Re: Former Texaco Service Station No. 21-1253
5280 Hopyard Road
Pleasanton, CA

Re: Response to Request for Pilot Test Work Plan or Draft Corrective Action Plan
Former Texaco Service Station 21-1253
930 Springtown Boulevard
Livermore, California
Fuel Leak Case RO0000189

Subject: Fuel Leak Case No. RO0000189 and Geotracker Global ID T0600101353, Chevron #21-1253/Texaco, 930 Springtown Boulevard, Livermore, CA 94550

Figure 2
 SITE PLAN WITH PROPOSED MONITORING WELL LOCATIONS
 FORMER TEXACO SERVICE STATION 21-1253
 930 SPRINGTOWN BOULEVARD
 Livermore, California

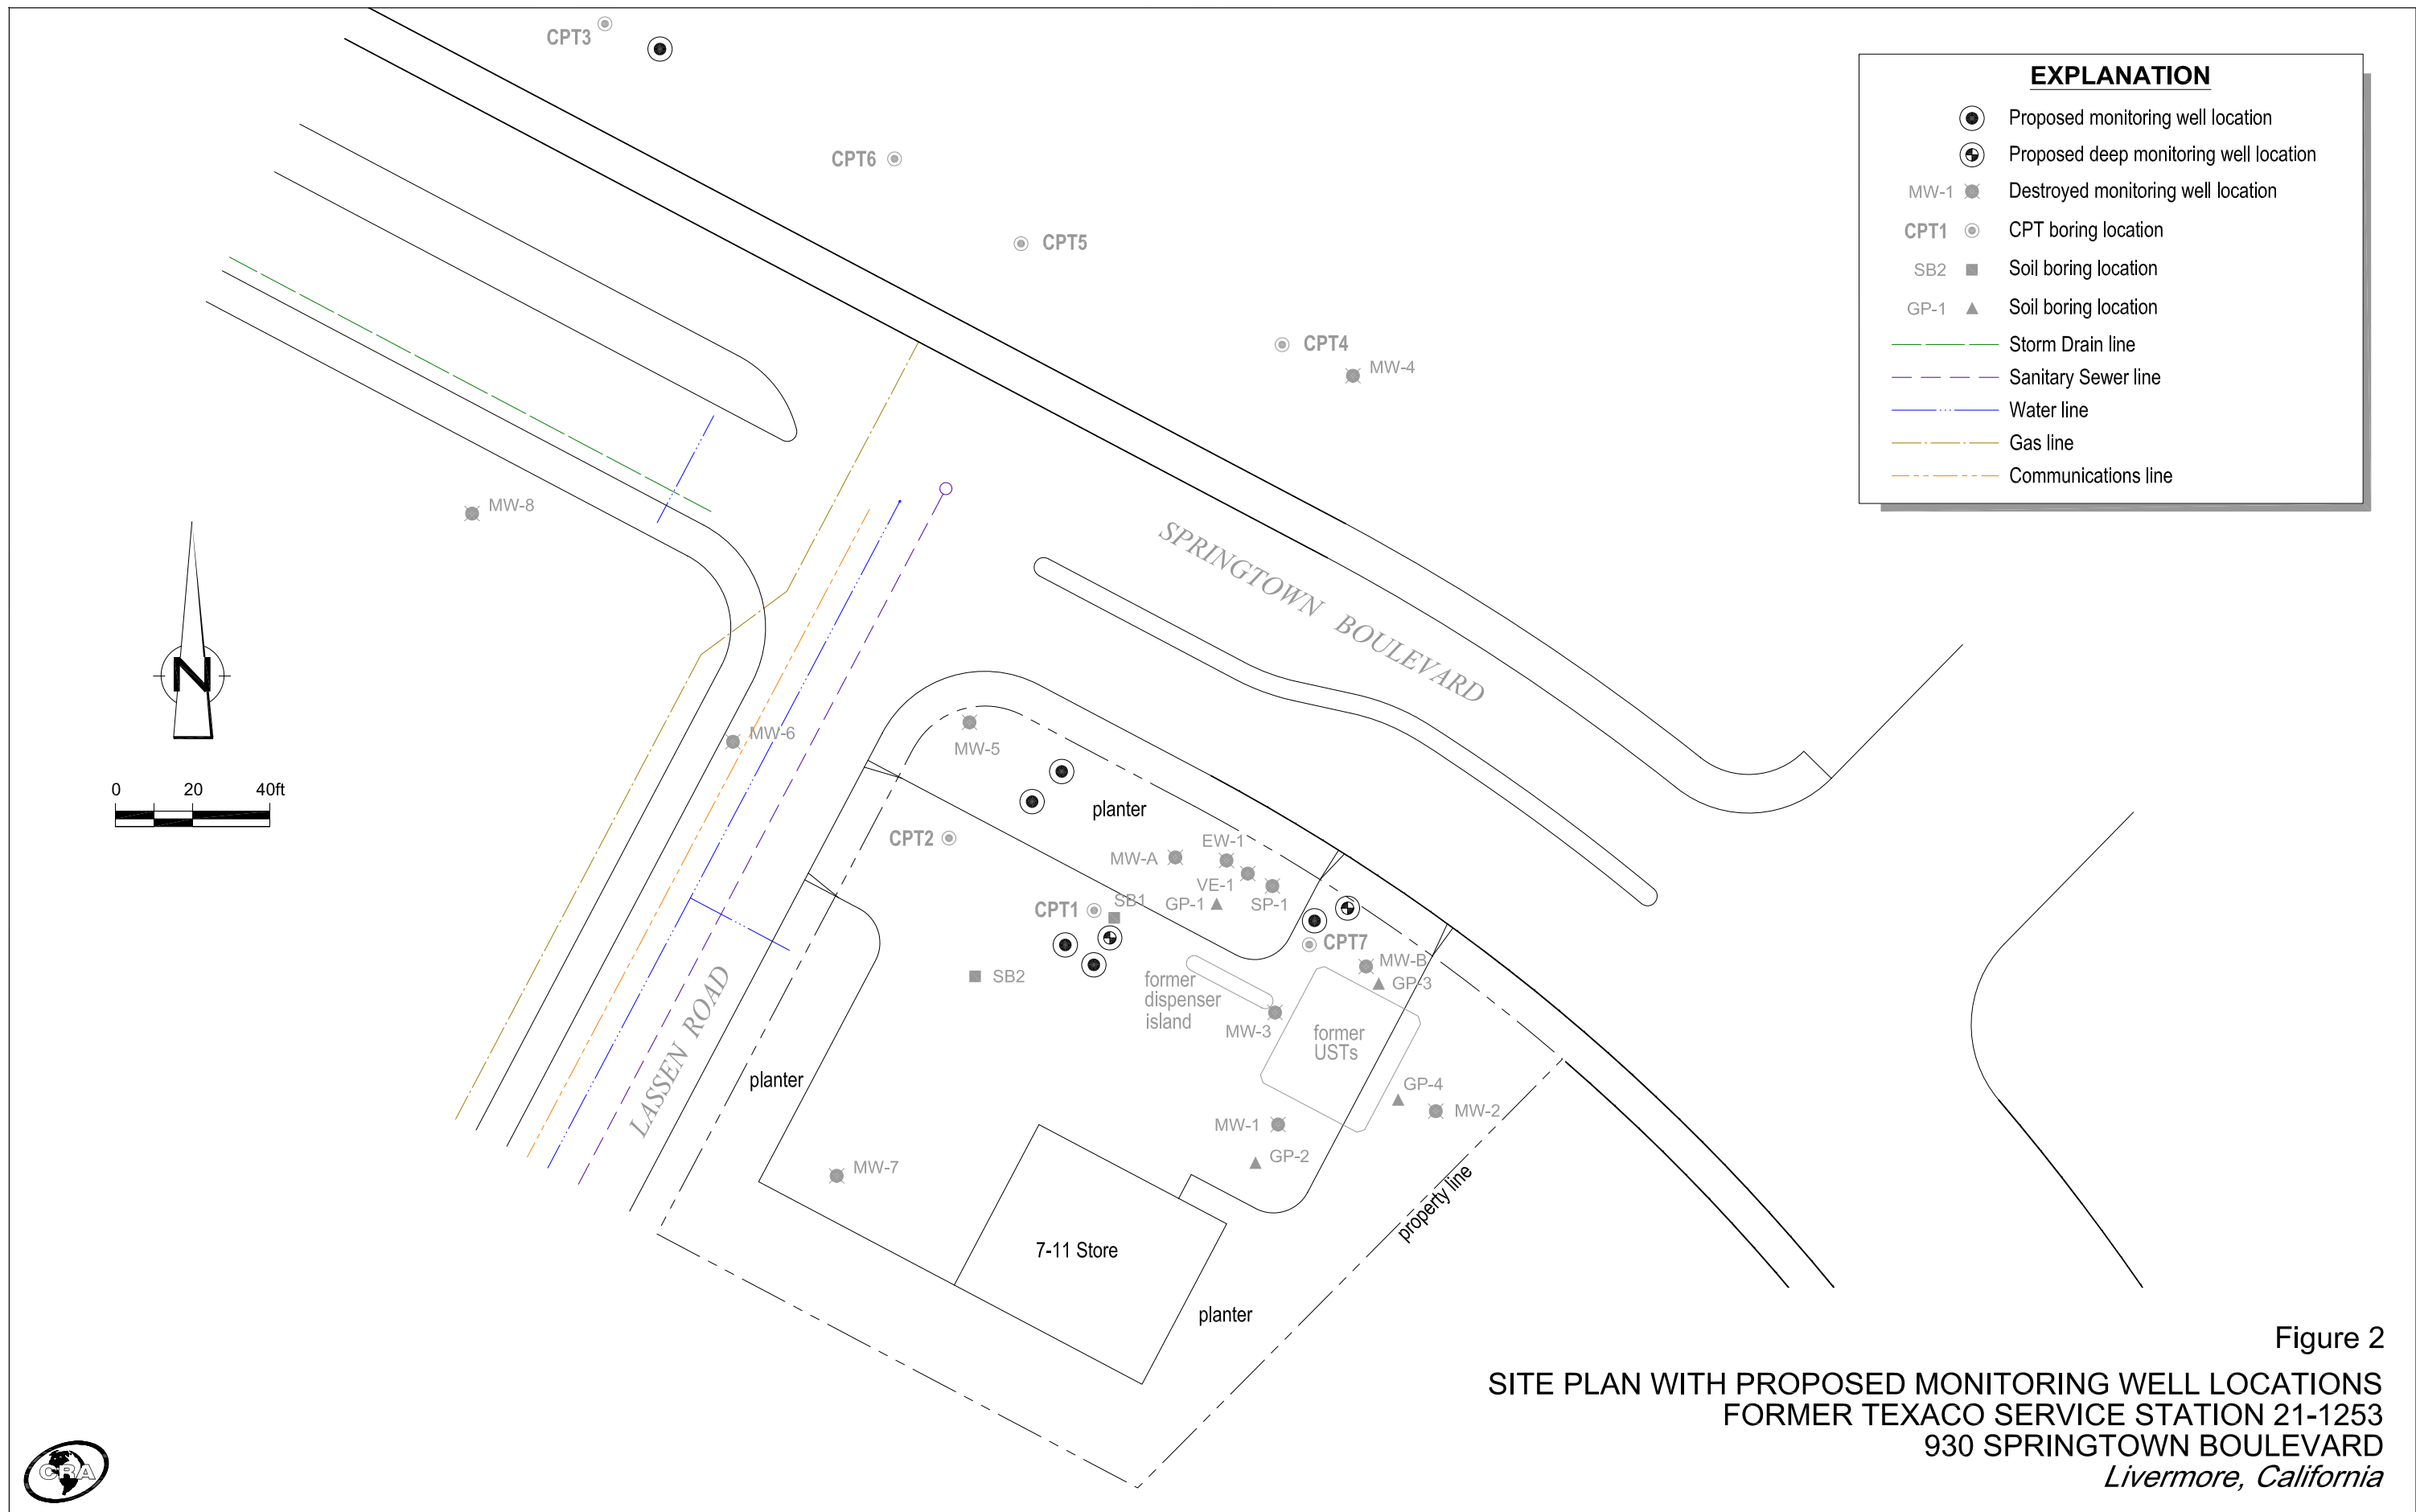
1. **Well Locations.** The proposed well locations are generally acceptable; however, we request that the proposed wells adjacent to CPT-1 and CPT-7 be moved short distances to locations that are more likely to be within the interior of the plume based on the locations of the former USTs and dispensers and the hydraulic gradient. We request that the proposed wells adjacent to CPT-1 be moved to locations immediately north of CPT-1 and the proposed wells adjacent to CPT-7 be moved to locations immediately south of CPT-7. The proposed well locations in the planter area and adjacent to CPT-3 are acceptable. However, please see the requested modifications and additional wells requested in technical comment 3.

2. **Proposed Depths of Well Screens.** Since 5 of the 6 proposed wells are in locations adjacent to CPT borings, we have compared the proposed depths of the well screen intervals to the CPT logs. Based on this comparison, we request the following modifications:

Proposed Well and Well Screen Interval	Requested Well Screen Interval
Shallow well adjacent to CPT-1: 5-15 feet bgs	No change.
Deeper well adjacent to CPT-1: 25-30 feet bgs	Install well screen within sand where highest concentration of TPH and BTEX was detected from 22-27 feet bgs. We also request that a third well be installed at this location with a screen interval from 32 to 37 feet bgs to monitor a lower sand layer where elevated concentrations of TPH and BTEX were detected in a grab groundwater sample from CPT-1.
Shallow well adjacent to CPT-7: 5-15 feet bgs	No change.
Deeper well adjacent to CPT-7: 25-30 feet bgs	No sand layer is present in CPT-7 log near depths of 25-30 feet bgs. We request that the well be screened in a lower sand layer observed on CPT-7 log from 42-47 feet bgs.
Shallow well in planter area north of CPT-1: 5-15 feet bgs.	No change.
Planter Area north of CPT-1: no deeper wells proposed	We request that an additional well with a screen interval from 22-27 feet bgs be installed within the Planter Area.

Shallow well adjacent to CPT-3: 5-20 feet bgs	We request that the well be screened within sand layer from 25-30 feet bgs.

ACEH has requested monitoring wells to be screened in multiple zones: 5-15 fbg, 22-27 and 25-30 fbg, 32-37 fbg and 42-47 fbg. All previous well data was based on groundwater monitoring wells screened in the same interval of approximately 5-25 fbg. It is necessary to assess groundwater conditions in these deeper zones that have not been previously monitored. In addition, no monitoring well data has been collected in over seven years. To select an appropriate remedial option that may need to address hydrocarbon concentrations at varying depths it is critical that we collect the following data:

This new data may rule out some remedial options that do not merit feasibility testing or determine that each zone requires a different remedial option. In addition, without this data we will be unsure how to scale the appropriate equipment or inject the correct chemical or quantities of chemical to successfully complete a feasibility test. Therefore, it is still necessary to monitor and sample the new monitoring wells for at least four quarters. After four quarters of groundwater data is collected, CRA will further evaluate the appropriate remedial options and recommend an appropriate feasibility test. The Monitoring Well Installation Report will be submitted to ACEH by August 19, 2009.
